RECALL

Ambulance Bus Litter Support Clamp

**Models Affected: 2007 through 2019 Model Year
All American Buses with Ambulance Litters**

RECALL CAMPAIGN - R I 8 Z O

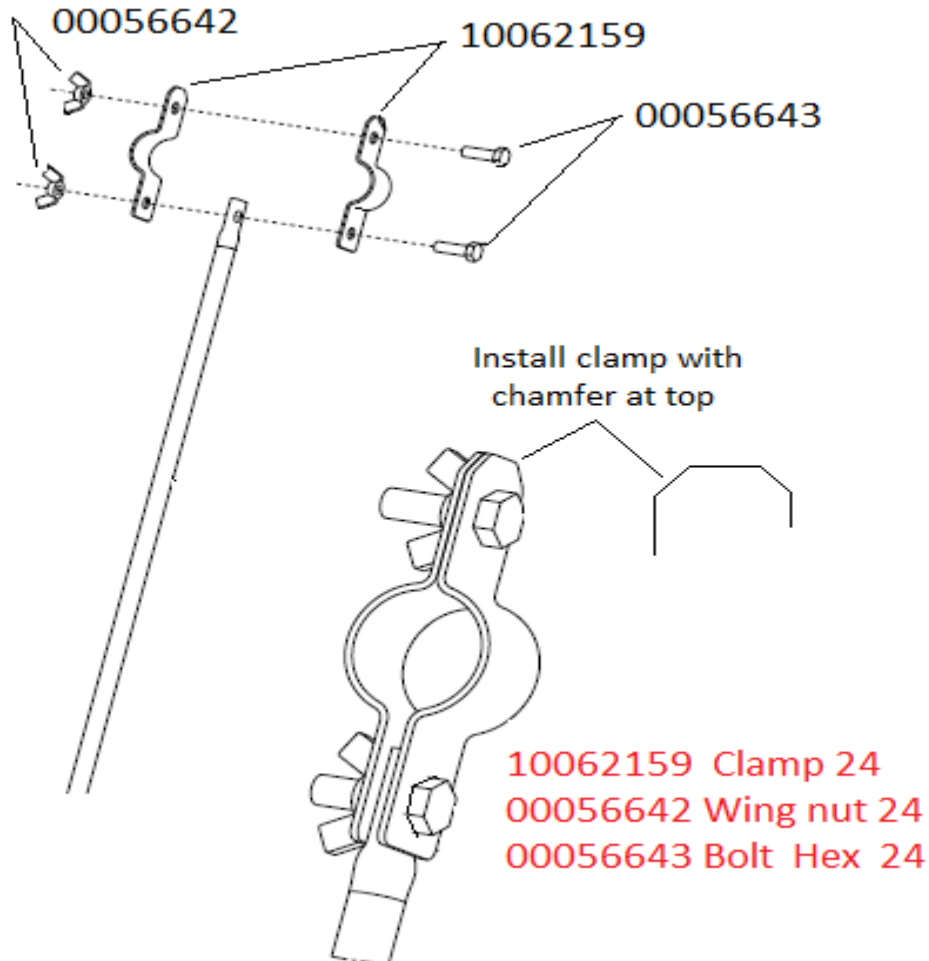
The top litter hanger support clamp may develop a crack and fail allowing litter to fall.

Remove the current clamps, 12 per unit and replace with the new clamps and fasteners.

1. Park bus on level surface, apply parking brake, turn of ignition key, and chock wheels.
2. Remove 5/16 wing nut and bolt from the upper loop clamp, remove current loop clamp.
3. Install the new support clamp assy. one at the front and one at the rear of each litter.
